Title		
Size	Number	Revision
A4		
Date:	2018/5/31	Sheet of
File:	F:\WORD-工作文档\...\01_Power_IN.Sch	Drawn By:

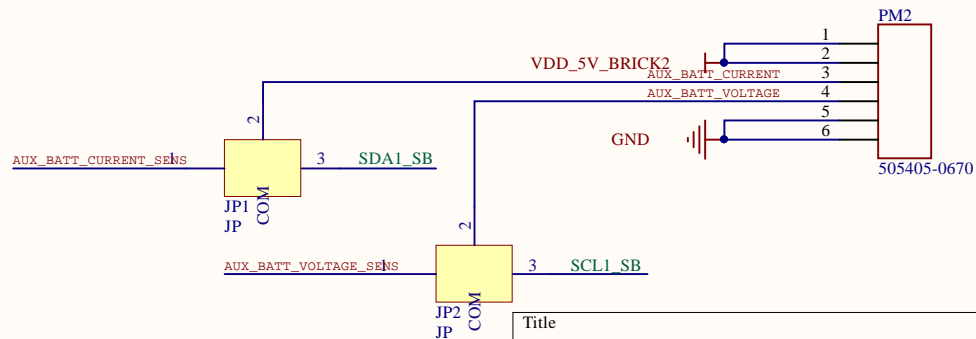
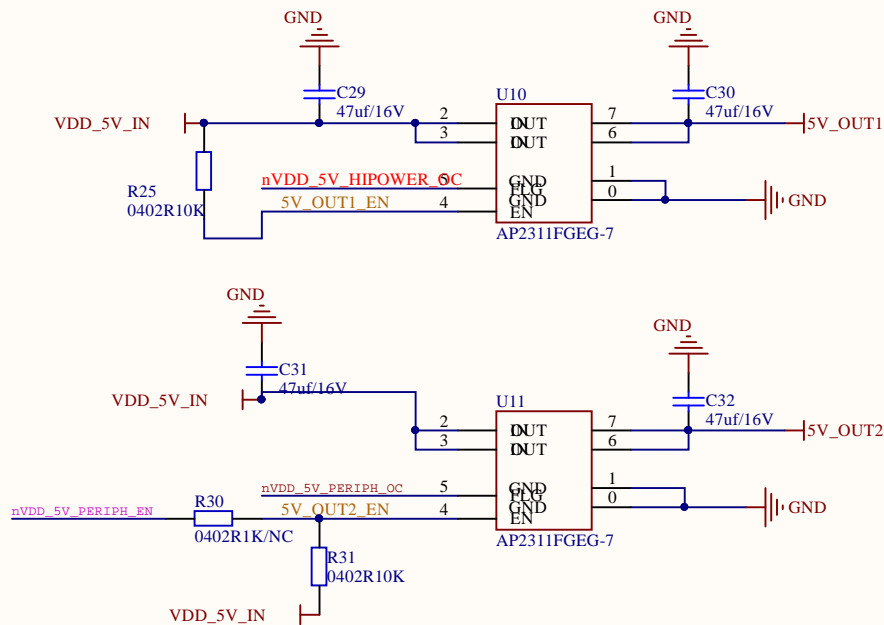
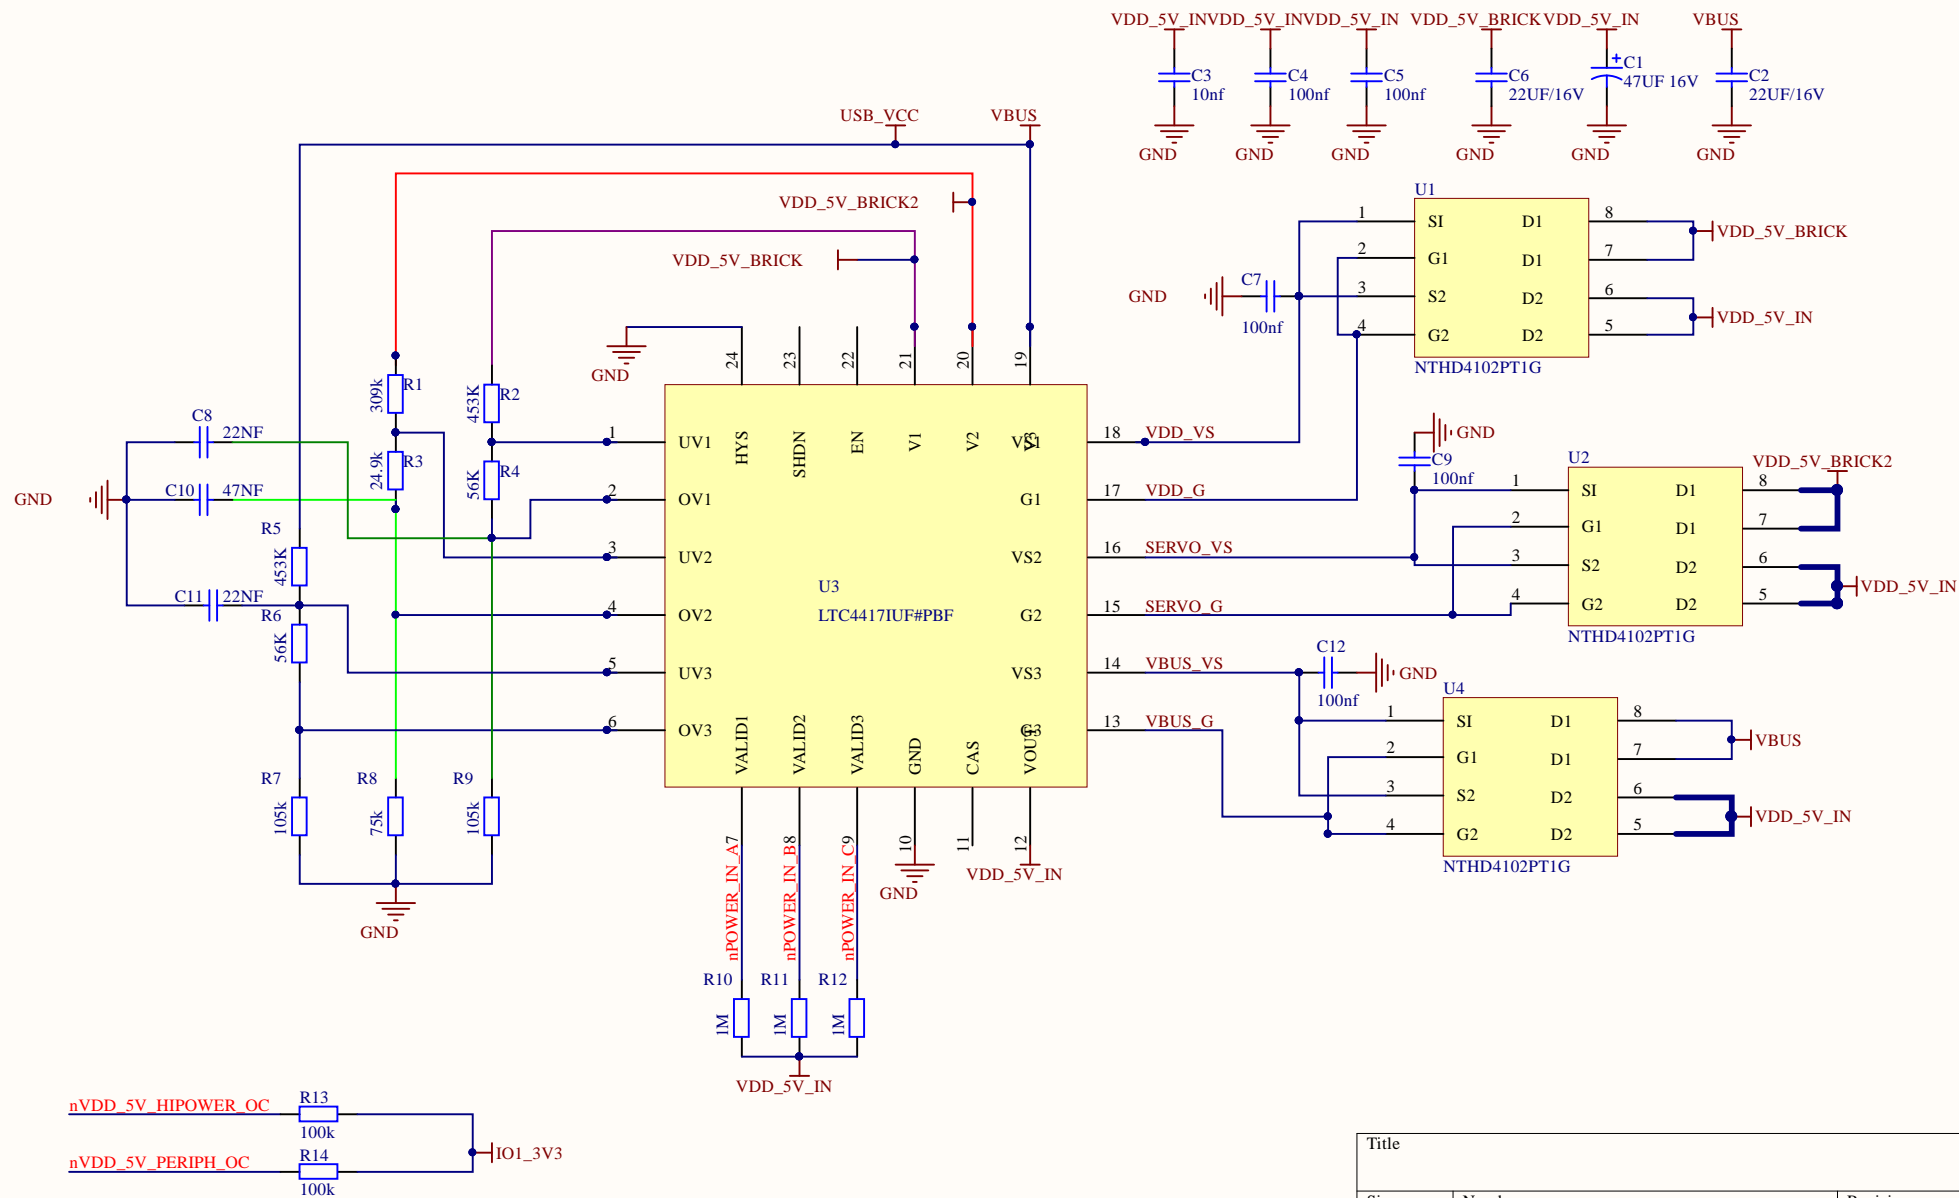
修改记录:
2018-5-29 修复主板电压检测引脚 SCALED_V5_CH_IN

Title		
Size	Number	Revision
A3		
Date:	2018/5/31	Sheet of
File:	E:\WORD>工作文档\05 DATA IO.Sch	Drawn By:

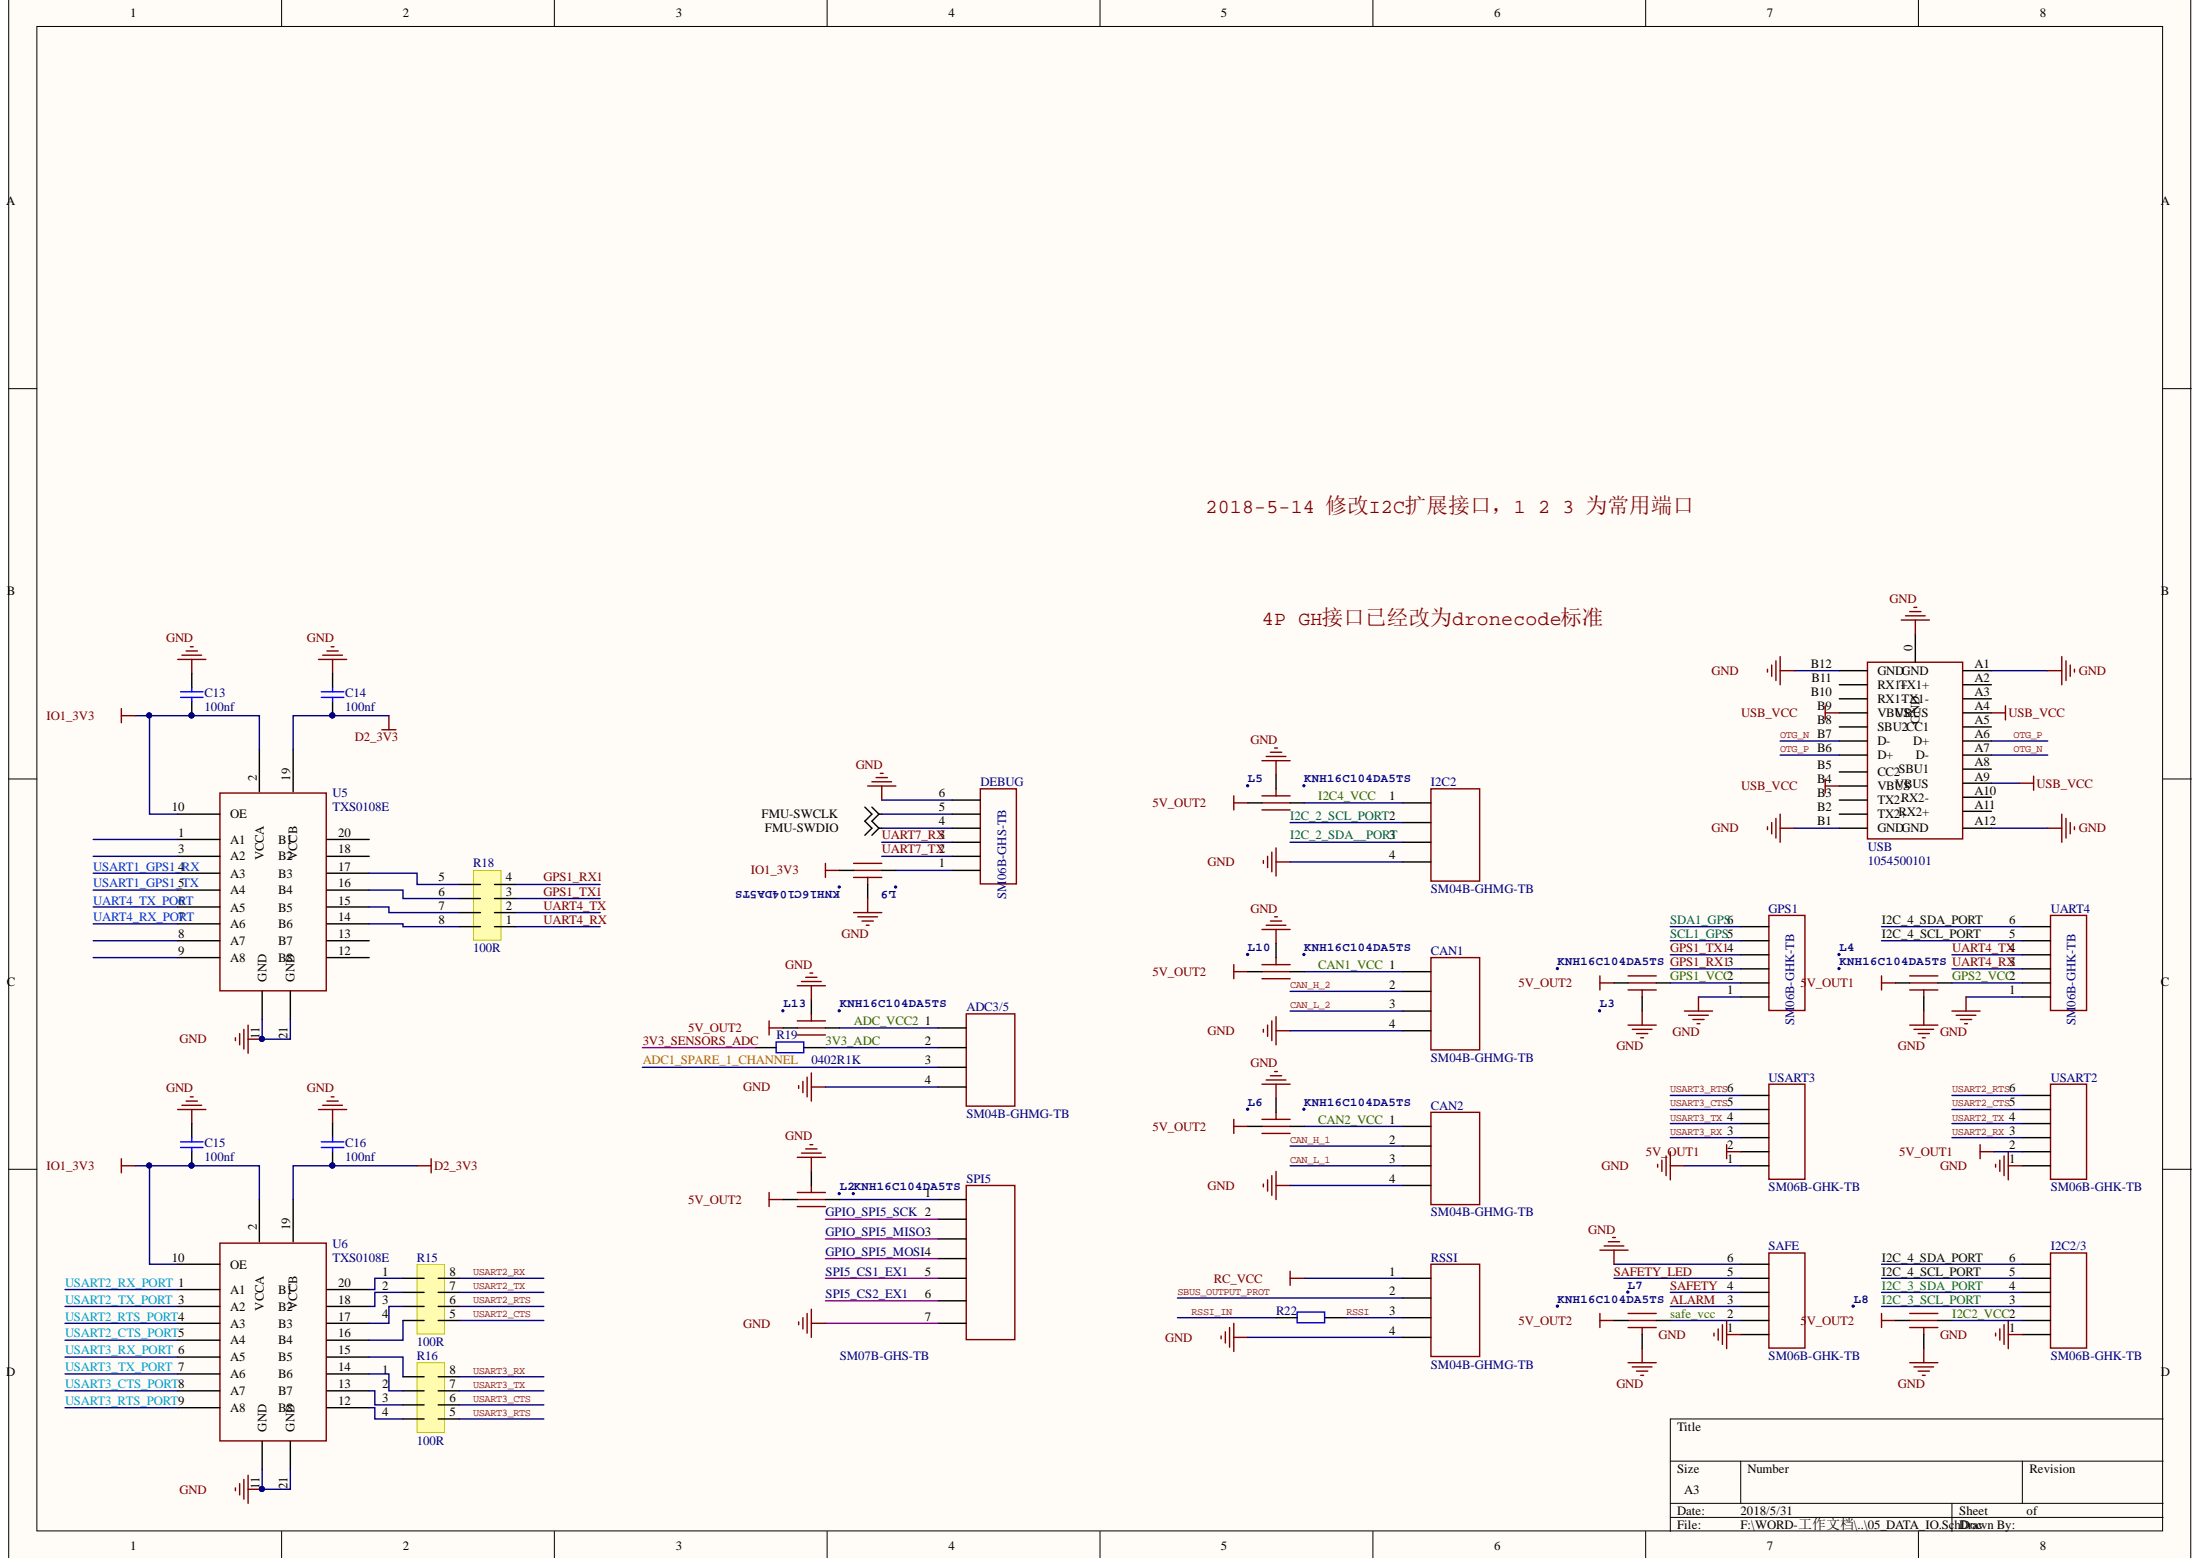
2018-5-14 修改I2C扩展接口, 1 2 3 为常用端口

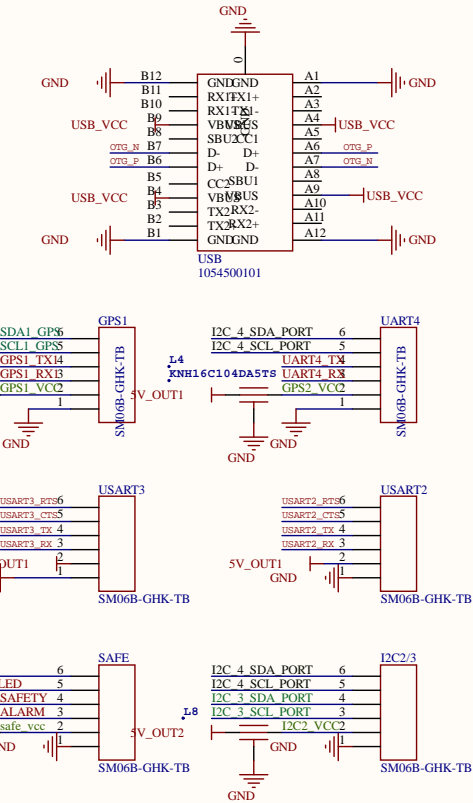
4P GH接口已经改为dronecode标准
